REG. PLAN No.	65M-4737
ZONE	RWS2
LOT NUMBER	LOT 53
LOT AREA (m²)	319.00
BLDG AREA (m²)	151.99
LOT COVERAGE (%)	47.65%
MAX HEIGHT (3.5 STOREYS)	
No. OF STOREYS	2 STOREYS

ROUNDEL HOMES INC. (PH-2)

LOT No. 53

PRAIRIE ROSE DRIVE

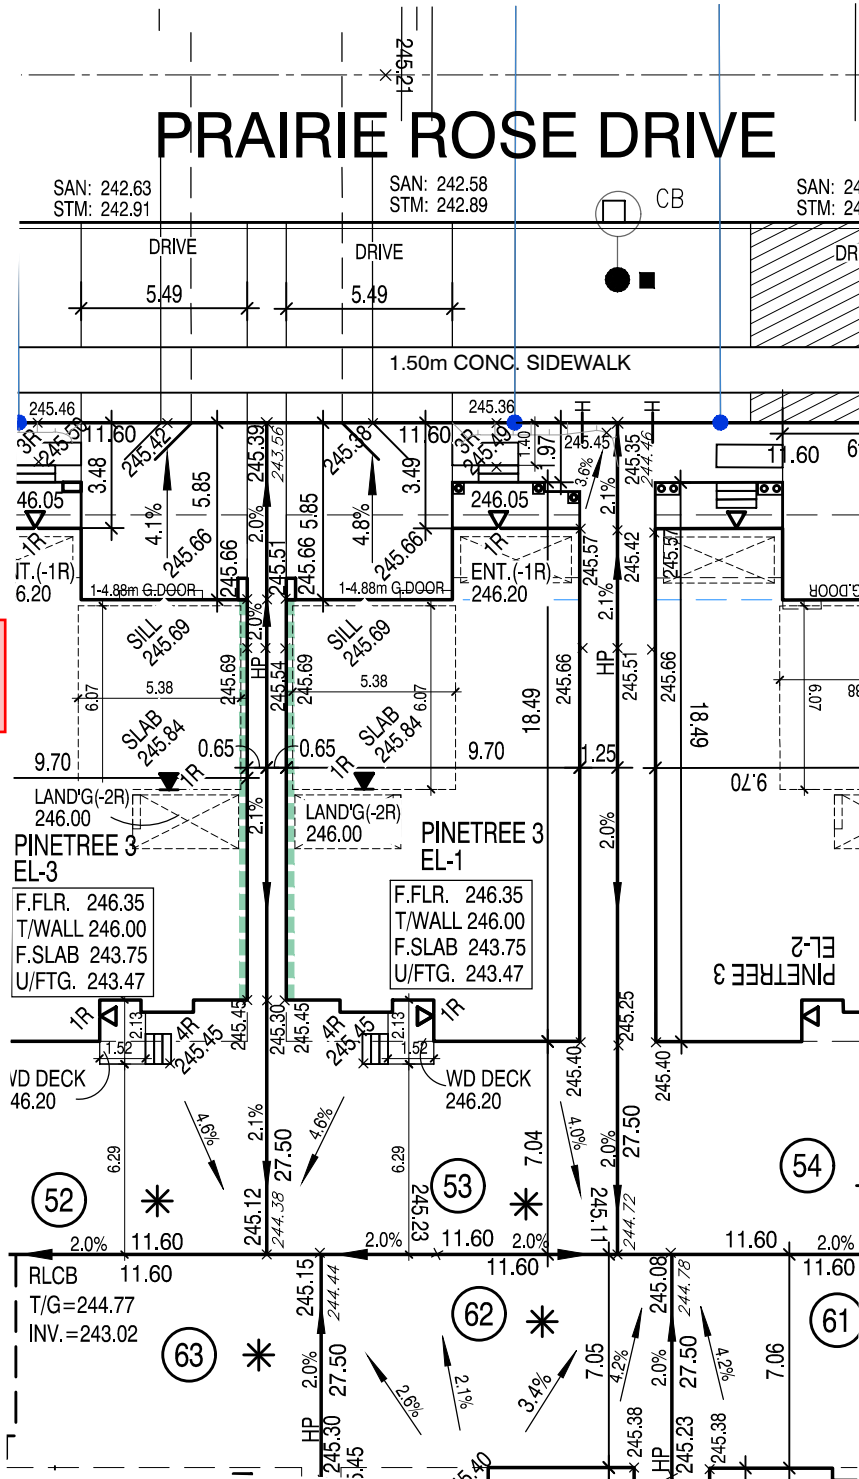
No unprotected openings permitted within 1.2 metres of the lot line as per 9.10.14 of the Ontario Building Code.

45 MINUTE RATED WALL
WITH SIDE YARD < 1.2m
